ADMINISTRATIVE SHORT PLAT REPORT & DECISION

REPORT DATE:	August 8, 2014
Project Name:	NE 7 th St North, Phase II Short Plat
Project Number:	LUA14-000868, SHPL-A
Project Manager:	Clark H. Close, Associate Planner
Owner:	Ron Craig, Attorney-In-Fact for Bettyjean Craig, 22821 112 th Place SE, Kent, WA 98031
Applicant:	Kyle Miller, KRRV DEV., LLC, P.O. Box 908, Ravensdale, WA 98051
Contact:	Darrell Offe, Offe Engineers, 13932 SE 159 th Pl, Renton, WA 98058
Project Location:	3518 NE 7 th Street, Renton, WA 98056

Recommendations: Plan review comments for NE 7th North Phase II Preliminary short plat (LUA 14-000868) (Date: 7/25/2014) I have completed a preliminary review for the above-referenced 4 lot short plat proposal at 3518 NE 7th Street. The following comments are based on the application submittal made to the City of Renton by the applicant.

NE 7TH NORTH PHASE 2 SHORT PLAT
KRIV DEVELOPMENT, LLC
PLAT MAP
3518 NE 7TH STREET

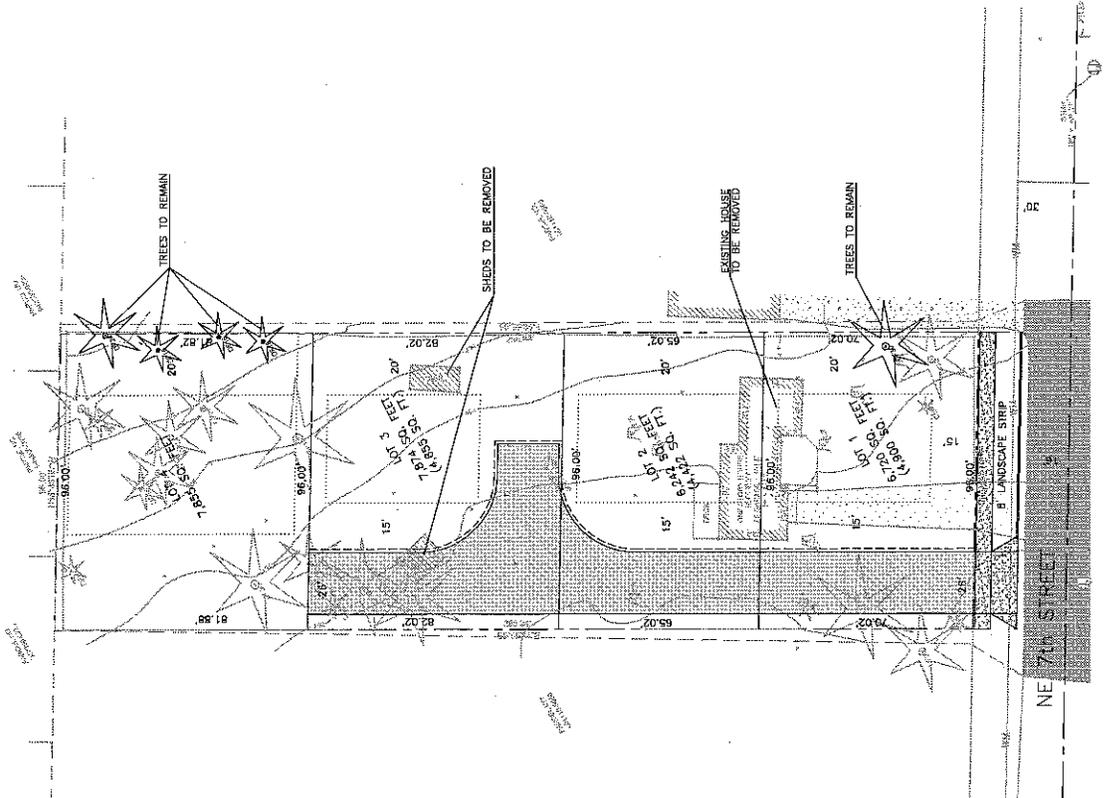
2. Water service details will be reviewed upon construction permit application. The current submitted plans show a dead end private road with a hammerhead. A 4" water main line is shown extending from the existing 8" water main on NE 7th Street fronting the site up to the south property line of the proposed Lot 4.

3. The water main is to be located at a minimum distance of four feet from the edge of the pavement of the private road. Relocate the water main from the location shown in the utility plan sheet. The minimum horizontal separation between water and sewer main is 10 feet.

4. Required 10 feet separation between the proposed sewer main and the water main should be provided.
5. The sewer main extension along the frontage of NE 7th Street is required, or the applicant is required to show during the utility construction stage that sewer connection from the sewer manhole on the south side of NE 7th Street to serve the lots on the east of the subject site will be possible.

2. The proposed private street has easement width of 26 feet and has a paved width of 20 feet. The minimum pavement thickness on a private street includes 4" of asphalt over 6" of crushed rock. The maximum grade for a private street shall not exceed 15%.

Show two ties to the City of Renton Survey Control Network. The geometry will be checked by the city when the ties have been provided. Although the coordinates shown purports to be based on the City's Survey Control Network (SCN), provide a direct tie

Do include a "LEGEND" block for the short plat drawing, detailing any symbols used thereon.

The City of Renton Administrator, PublicWorks Department, is the only city official who signs the final short plat. Provide an appropriate approval block and signature line. Pertinent King County approval blocks also need to be noted on the drawing.

WASHINGTON
 3518 NE 7TH STREET
 LANDSCAPE PLAN
 NE 7TH NORTH - PHASE 2

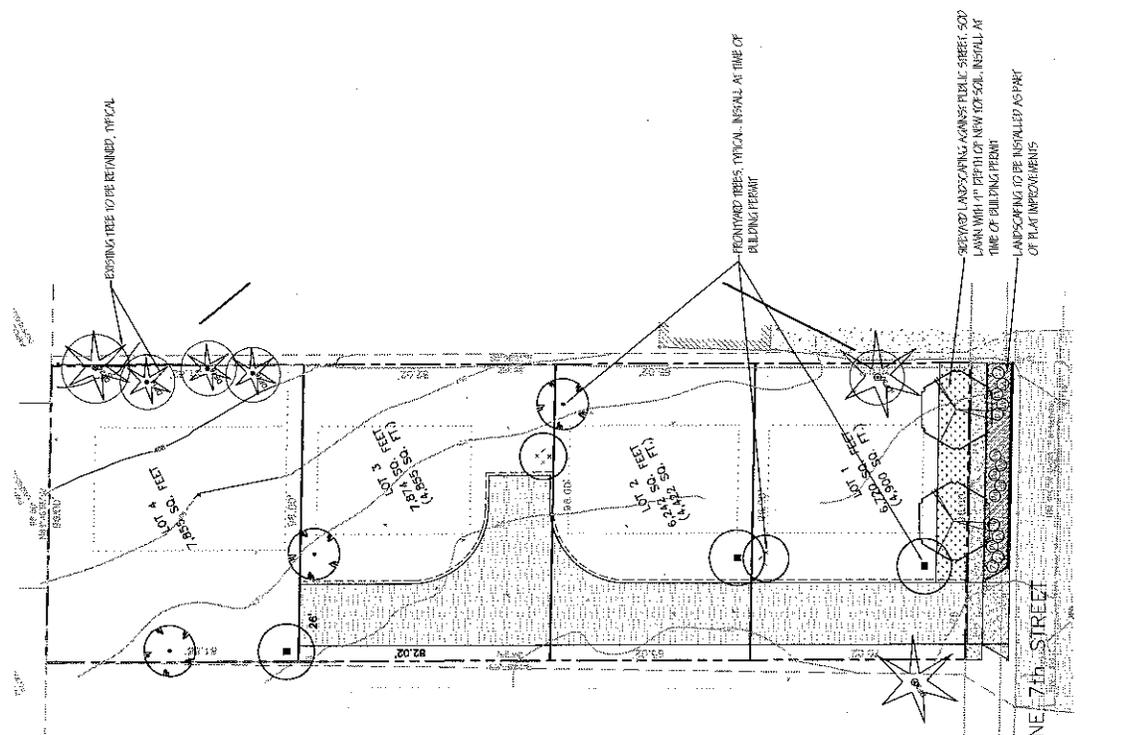
<p>✓</p>	<p>Landscaping: Ten feet of onsite landscaping is required along all public street frontages, with the exception of areas for required walkways and driveways per RMC 4-4-070. Such landscaping shall include a mixture of trees, shrubs, and groundcover as approved by the Department of Community and Economic Development.</p> <p>Minimum planting strip widths between the curb and sidewalk are established according to the street development standards of RMC 4-6-060. Street trees and, at a minimum, groundcover are to be located in this area when present.</p> <p>Where there is insufficient right-of-way space or no public frontage, street trees are required in the front yard.</p> <p><i>Staff Comment:</i> There are no trees proposed within the landscape planter strip between the back of curb and sidewalk due to the addition of underground utilities as part of this project. Tree roots will negatively impact the underground utilities at this location and those trees are proposed to be relocated onsite. RMC 4-7-070F allows street trees to be relocated onsite subject to approval of the Administrator. A minimum of two (2) trees are to be located in the front yard prior to final inspection. The applicant is proposing two (2) onsite maple trees at 1-1/2" caliper in the required ten feet of onsite landscaping along the public frontage. (Exhibit 6). In order to meet the landscaping requirements the 10-foot onsite landscaping strip shall include a mixture of trees, shrubs, and groundcover. This is a condition of the short plat approval. The final detailed landscape plan shall be submitted to and approved by the Current Planning Project Manager prior to construction permit issuance.</p>

<p>✓</p>	<p>Tree Retention: RMC 4-4-130 required thirty percent of the trees shall be retained in a residential development.</p> <p><i>Staff Comment:</i> There are a total of 23 trees located onsite of which five (5) are proposed to be retained. The applicant is required to retain 30 percent of the trees located on site that are not located within critical areas, proposed rights-of-way and access easements. The applicant indicates seven (7) trees onsite would be excluded from the tree retention</p>

<p>calculations due to their location in proposed right-of-way, utility, and access easement corridors; therefore, the five (5) trees proposed to be retained meets the minimum 30% tree retention requirement (Exhibit 5).</p>
✓	<p>Parking: Each unit is required to accommodate off-street parking for a minimum of two vehicles.</p> <p><i>Staff Comment:</i> Sufficient area exists, on each lot, to accommodate off street parking for a minimum of two vehicles.</p>
<p>3. DESIGN STANDARDS:</p>	
<p>Residential Design and Open Space Standards (RMC 4-2-115) are applicable in the R-8 zone. The Standards implement policies established in the Land Use and Community Design Elements of the Comprehensive Plan. Compliance with Site Design Standards must be demonstrated prior to approval of the subdivision. Compliance with Residential Design Standards would be verified prior to issuance of building permits. The proposal is consistent with the following design standards, unless noted otherwise:</p>
